CITY OF FORT BRAGG

DATE: September 30, 2022
TO: Heather Gurewitz
FROM: Diane O'Connor; Assistant City Engineer, Public Works
SUBJECT: PW Comments for CDP 10-22; 840 S Franklin Mixed-Use

CURB, GUTTER AND SIDEWALK

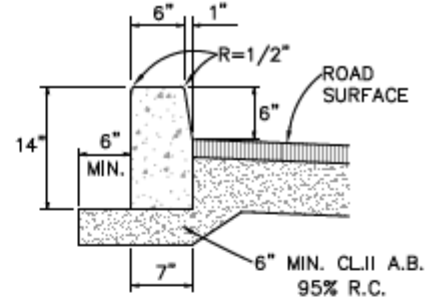
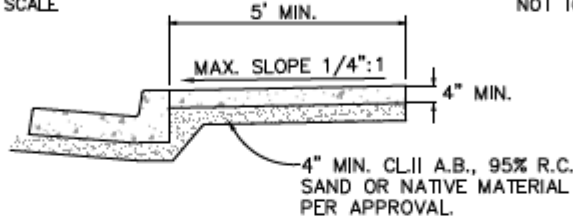
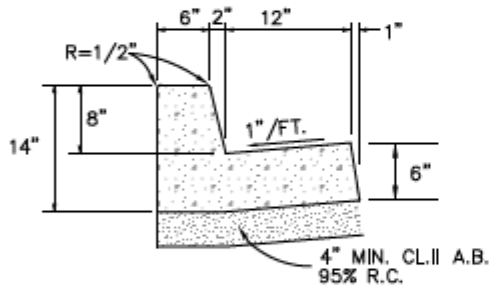
- a. Applicant shall install new sidewalk per City Standard 205 on S Franklin Street for the length of the project frontage.
- b. Applicant shall install new curb, gutter and sidewalk per City Standard 205 along the length of the project frontage on Myrtle. This also includes any subgrade and AC paving necessary to connect the existing pavement to the new gutter, per City Standard 215.
- c. Please submit the plans for frontage improvements to the Public Works Department for approval with the building permit application submittal.
- d. Frontage improvements shall be completed prior to final of the building permit.
